SH-BCU-66

CADDY NO. 1398 ITEM NO. 12

JOB: UNIVERSITY HOSPITAL OF CLEVELAND
LOC: CLEVELAND, OHIO
CUST:
CUST#:

DWG# D-1-1398 SHT 1 OF 7

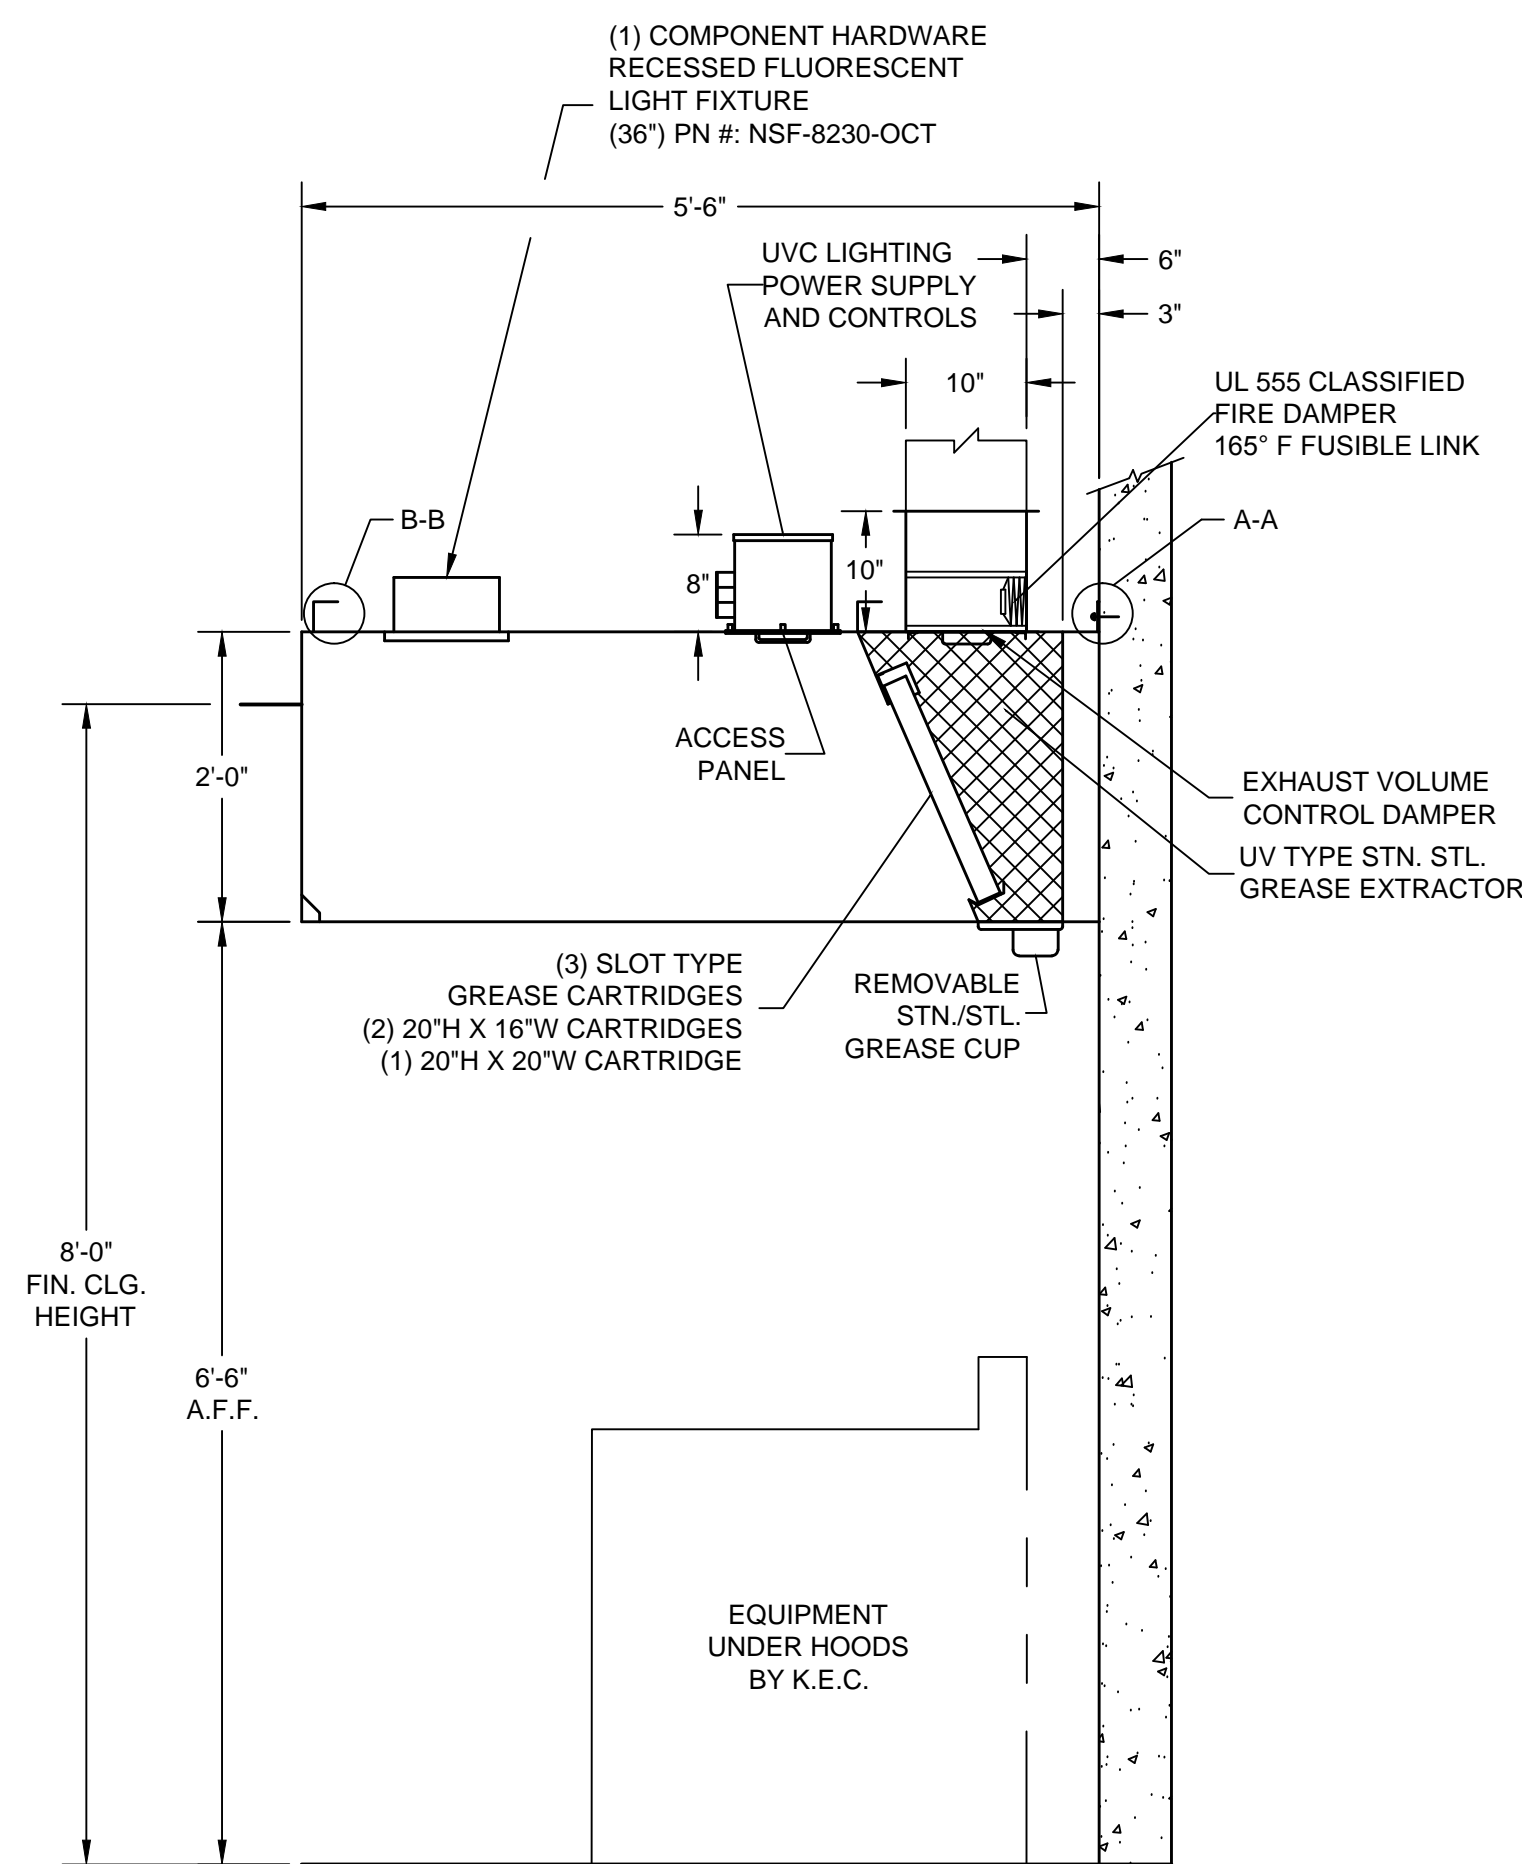
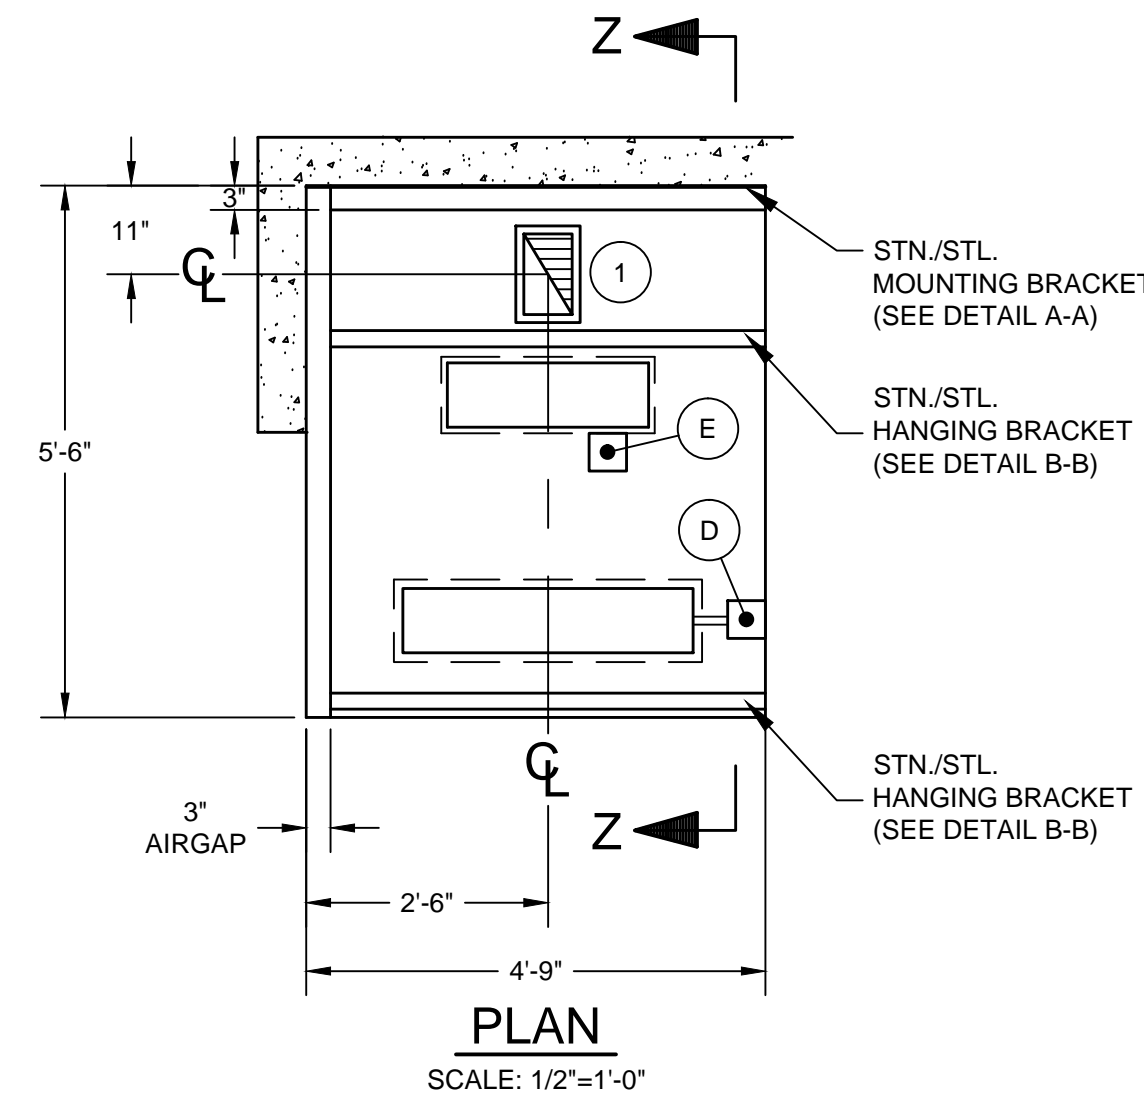
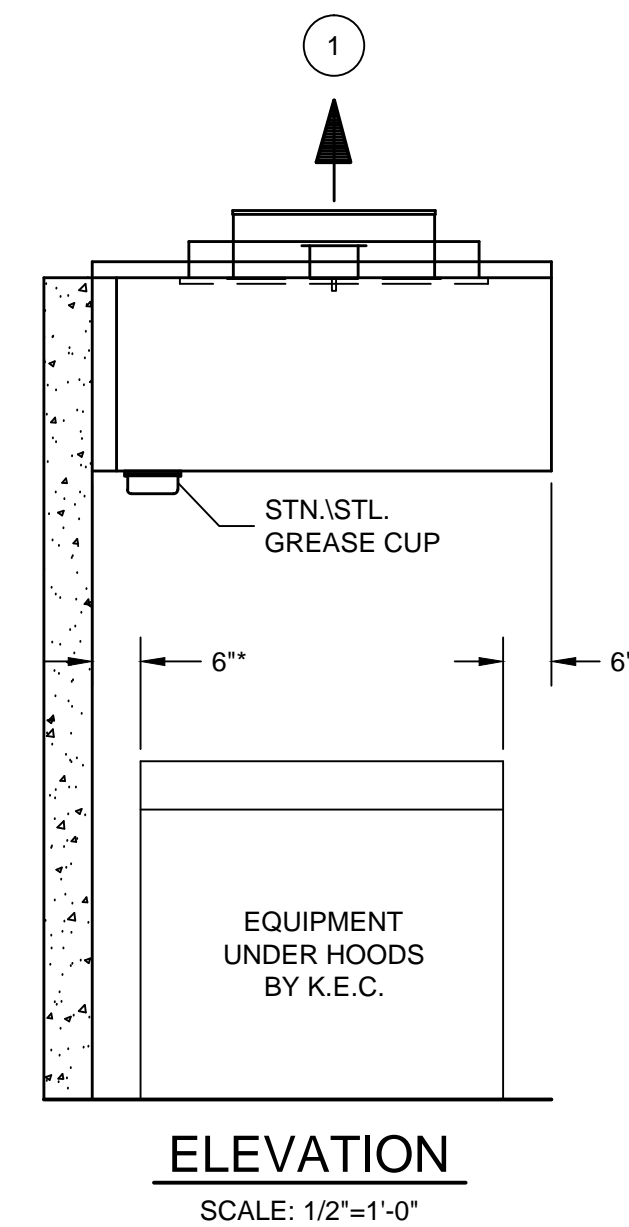
REVISIONS			
REV	DATE	BY	REMARKS
A	9-24-04	SWL	REVISED PER PHONE CONVERSATION WITH PAUL BERNISKY OF H-MAK ON 09/24/04. REVISED HEIGHT OF THE VENTILATOR FROM 30" TO 24". REVISED VENTILATOR LENGTH OF 4'-6" TO 4'-9" LONG. CENTER LINE OF THE EXHAUST DUCT FROM 2'-4 1/2" TO 2'-6". FINISHED CEILING HEIGHT FROM 9'-0" TO 8'-0". CHANGED THE C.F.M.'S AND EXHAUST DUCT PER VENTILATOR LENGTH CHANGE.
B	9-28-04	SWL	FABRICATED PER APPROVED DRAWING FROM PAUL BERNISKY OF H-MAK ON 09/27/04.
C	10-6-04	SWL	NO CHANGES TO THIS SHEET
D	11-29-04	SWL	NO CHANGES TO THIS SHEET

SH-BCU-54

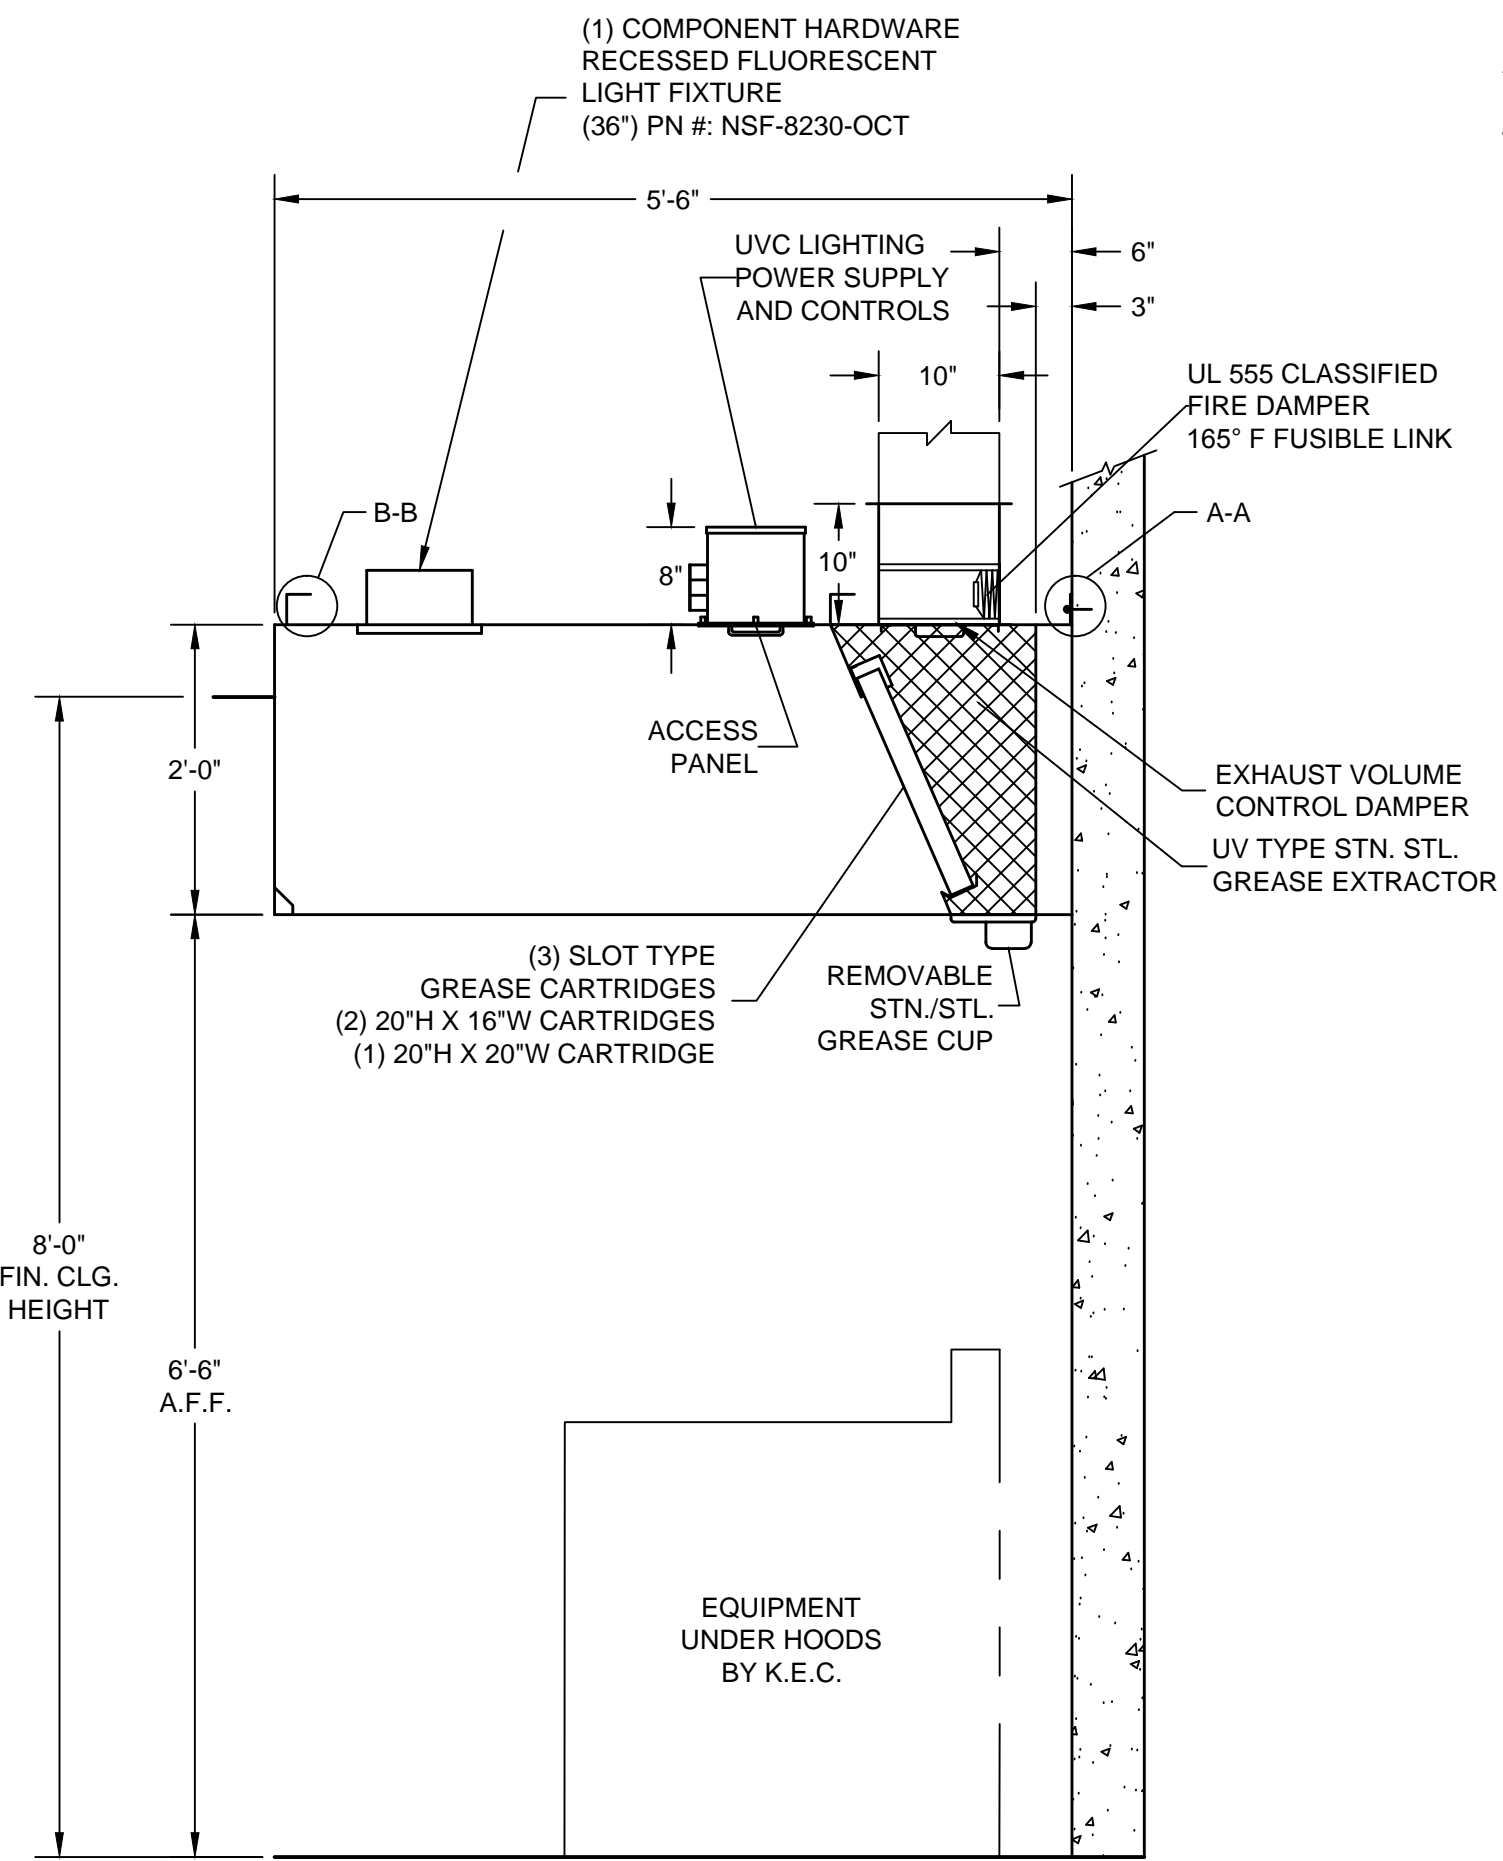
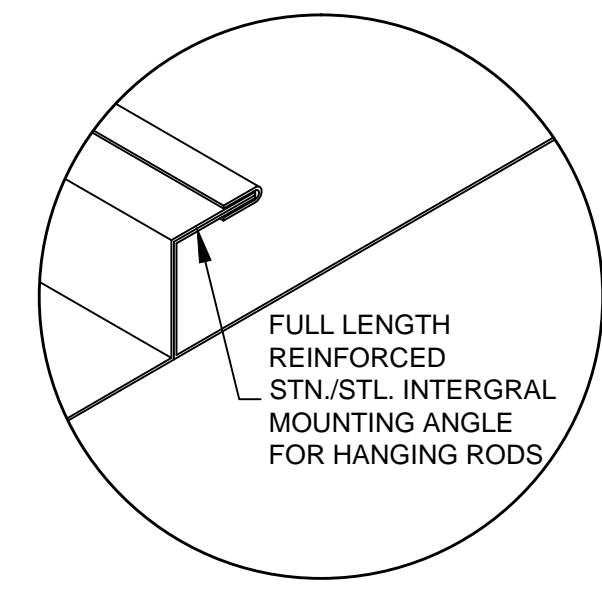
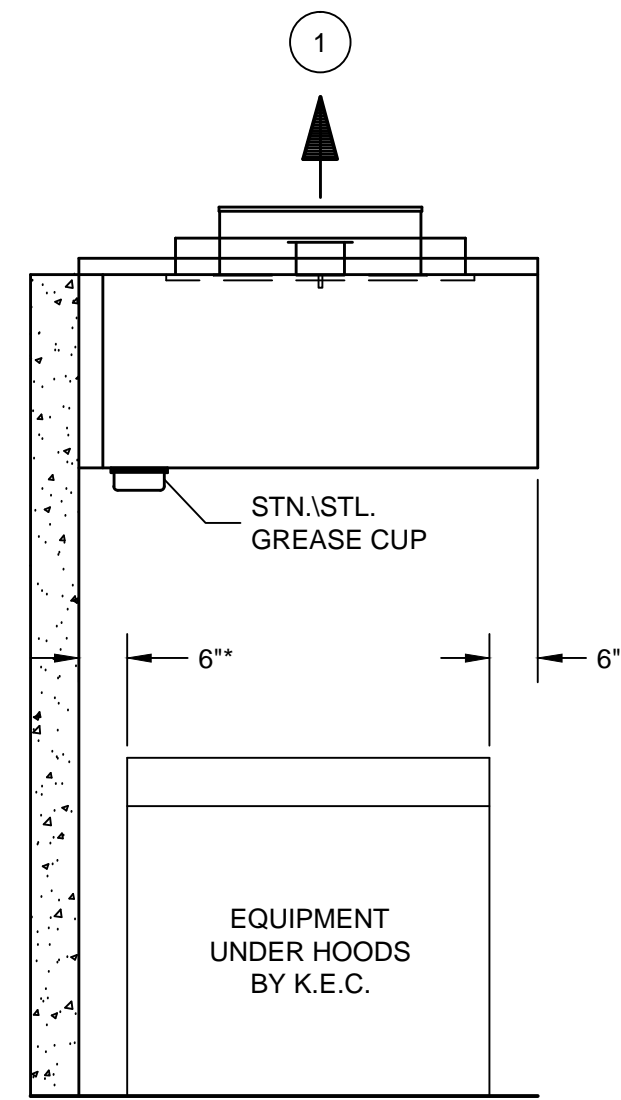
REVISIONS			
REV	DATE	BY	REMARKS
A	9-24-04	SWL	REVISED PER PHONE CONVERSATION WITH PAUL BERINSKY OF H-MAK ON 08/24/04. REVISED FINISHED CEILING HEIGHT FROM 9'-0" TO 8'-6". REVISED THE HEIGHT OF THE VENTILATORS FROM 34" TO 24".
B	9-28-04	SWL	FABRICATED PER APPROVED DRAWING FROM PAUL BERINSKY OF H-MAK ON 08/27/04. REVISED FINISHED CEILING HEIGHT FROM 8'-6" TO 8'-0".
C	10-6-04	SWL	NO CHANGES TO THIS SHEET
D	11-29-04	SWL	NO CHANGES TO THIS SHEET
